Ward Tay Bridges

Proposal
Elevational alterations

Proposed Shopfront Alterations in North Lindsay Street

The elevational alterations are **RECOMMENDED FOR REFUSAL**. Report by Director of Planning and Transportation

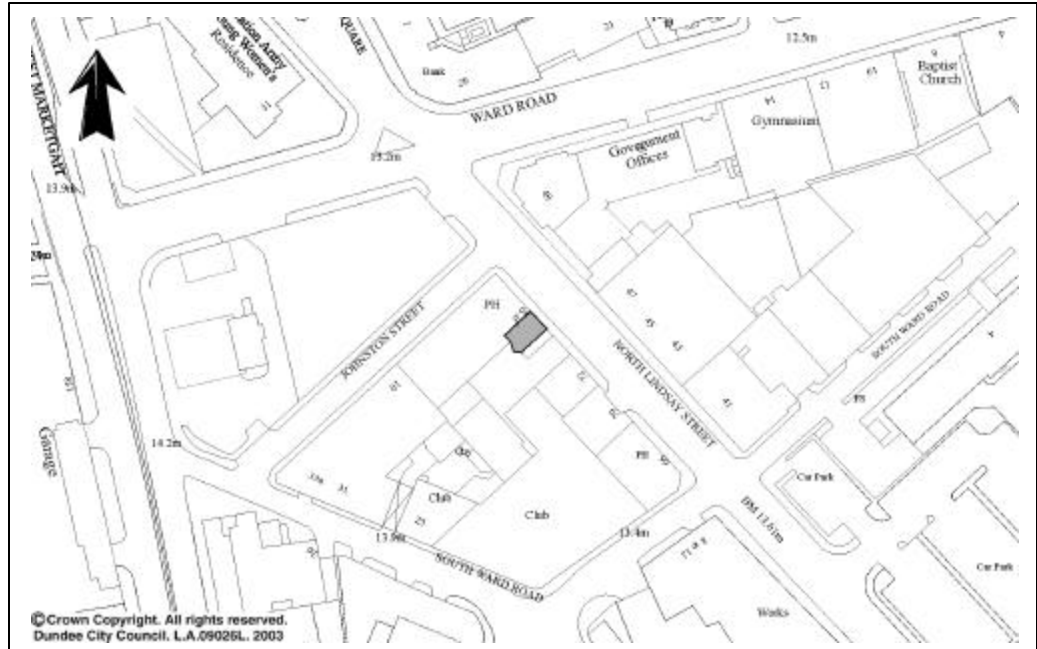
- The Architectural Heritage Society of Scotland has objected to the proposal on the grounds that the window is badly sited and disrupts the symmetry and proportions of the front elevation of the overall building.

- It is considered that the window forms an incongruous, conspicuous feature on this important elevation and due to its siting, style and proportions disrupts a well balanced symmetrical frontage to the detriment of the appearance and character of the building. As such the proposal is contrary to the terms of national guidance and the statutory requirement as well as local plan policy. Accordingly refusal of the application is recommended.

Policy BE17 indicates that any alterations to listed buildings should have regard to the architectural and historic character of the building. The proposed window is neither of a scale or appearance that complements the other windows on the southern (main) elevation. It is sited in a position where it is disruptive, conspicuous and presents an incongruous element on an otherwise interesting frontage. It is considered that the proposal does not respect the architectural character and appearance of the building and therefore is contrary to policy BE17.

The Memorandum of Guidance on Listed Buildings and Conservation Areas para 1.2.1 indicates that additional windows should always be refused when inserted into original symmetrical or well-balanced elevations with a high wall to window ratio. This point has been raised by the Architectural Heritage Society of Scotland and is considered valid.

The design of the window is considered to be out of scale and proportion with others on the elevation and is sited in a located where it is conspicuous and disrupts the rhythm and symmetry of the architectural elements.

- 1 That the proposed window by virtue of its siting, design and external appearance does not have due regard to the building's special architectural features or its historic interest and therefore fails to meet the statutory requirement outlined in section 59 of the Planning (Listed Buildings and Conservation Areas) (Scotland) Act 1997 and stated in para. 42 of NPPG 18.
- 2 That the proposed alterations to this listed building do not have due regard to the restoration or enhancement of the architectural and historic character of the building, by virtue of the siting, scale and proportions of the window and as such is contrary to policy BE17 of the Dundee Local Plan 1998.
- 3 That the proposal is contrary to the advice given in the Memorandum of Guidance on Listed Buildings and Conservation Areas para. 1.2.1 as it represents the insertion of a window into an original,
